Response to Reviewer 1

The manuscript by Schmitt et al. demonstrates the development and deployment of a near-infrared open-path dual-comb spectroscopy system for CO₂ (and CH₄) observation over the city of Heidelberg. The manuscript is well-written and describes the dual-comb system well. While the authors demonstrate the good precision of the system for the concentration of CO₂, the ambiguous position of CH₄ in the manuscript needs to be addressed before this manuscript can be recommended for publication.

Response to Reviewer 2

Response to Reviewer 3

Figure R1: Distribution of the differences between the two instruments as a function of temperature. Binning in intervals of 5 K. Bins below 270 K and above 300 K are excluded due to low statistics.

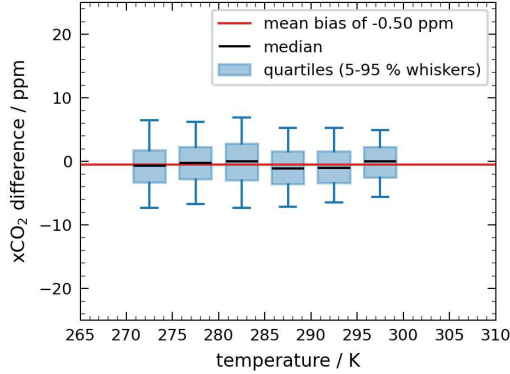
2. The comparison to the co-deployed FTIR yields a positive bias of the DCS instrument of 0.16 ppm CO₂. Since this is a major outcome in this work, further elaboration on the nature of this bias would be appropriate. For example, do the residuals of both instruments for the longest possible averaging time (thus minimal noise) show certain differences in how well absorption lines are fitted? Do both instruments fit the same absorption lines of CO₂ or could the difference be explained by line list discrepancies between the different absorption lines? And is the bias stable over the fluctuations in pressure and temperature, or is the bias a temperature effect? Particularly, an analysis of the bias over varying ambient temperature could be interesting.

Reply: There are no obvious differences in the fit residuals between the instruments, but please keep in mind that the FTIR spectra cover individual lines only with a few samples each. So a one-to-one comparison of the spectra is difficult. Both instruments fit the CO₂ absorption lines at 1.6 μ m and the FTIR instrument makes use of the absorption band at 2 μ m additionally. We made the description in the manuscript clearer. The bias is not a temperature effect and indeed stable over the temperature range from 270 K to 300 K that our data covers (see Fig. R1).
